Agenda item:	“HSDPA discussion”
Source:	Ericsson
Title:	Discussion on topics and issues raised on fast Hybrid ARQ proposals for HSDPA
Document for:	Discussion

Figure 1

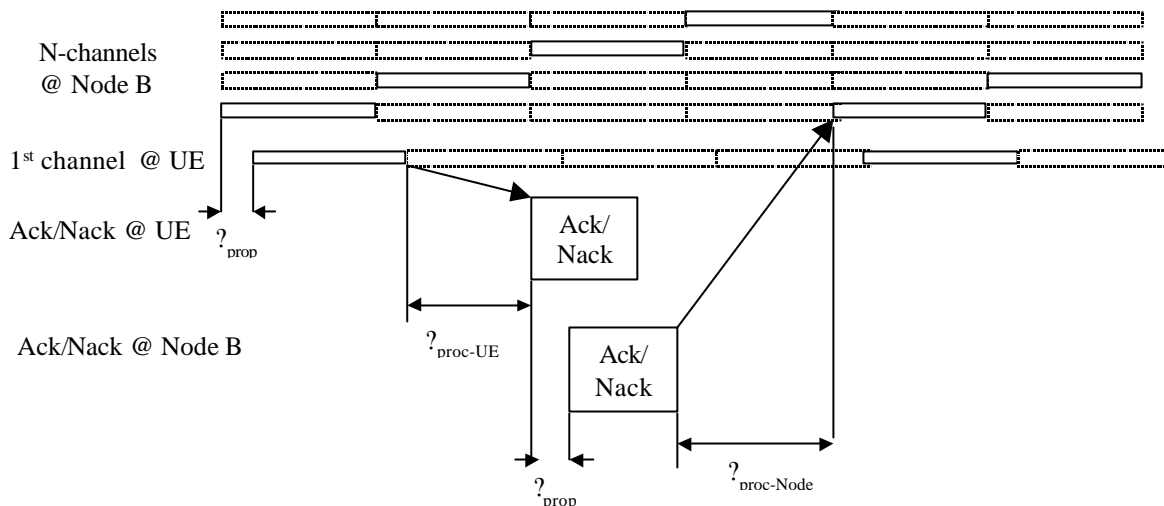
As a reference, Figure 1 illustrates the N-channel Stop-&-Wait protocol with N=4 (example).

The key property of the N-channel Stop-&-Wait protocol is that the received timing of an Ack/Nack identifies the acknowledged data block. This is the reason why N-channel Stop-&-Wait allows for multiple not-yet-acknowledged data blocks without explicit sequence numbers. As a consequence there are strict requirements on the transmission timing of the Ack/Nack (relative to the receive timing of the data block) and thus strict limits on the available UE processing time $t_{UE-proc}$. Thus the time needed to decode data received in an HSDPA TTI and to generate a corresponding Ack/Nack is one of the critical issues to be studied for HSDPA HARQ.

Figure 2

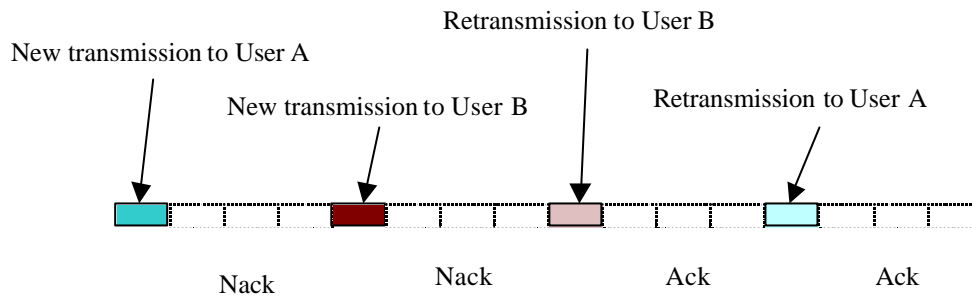
Our understanding is that the N-channel Stop-&-Wait scheme allows for time-multiplexing of different users in the sense that a block of data transmitted to and not correctly decoded by User A in the Mth HSDPA TTI does not necessarily have to be retransmitted in the (M+N)th HSDPA TTI, i.e. the next TTI in the given HARQ channel. Instead, N-channel Stop-&-Wait allows for transmission to User B in (M+N)th HSDPA TTI while the retransmission to User A is postponed to a later TTI belonging to the Nth HARQ channel, see also Figure 2.

Thus also N-channel Stop-&-Wait supports a certain degree of so-called “asynchronous” operation.
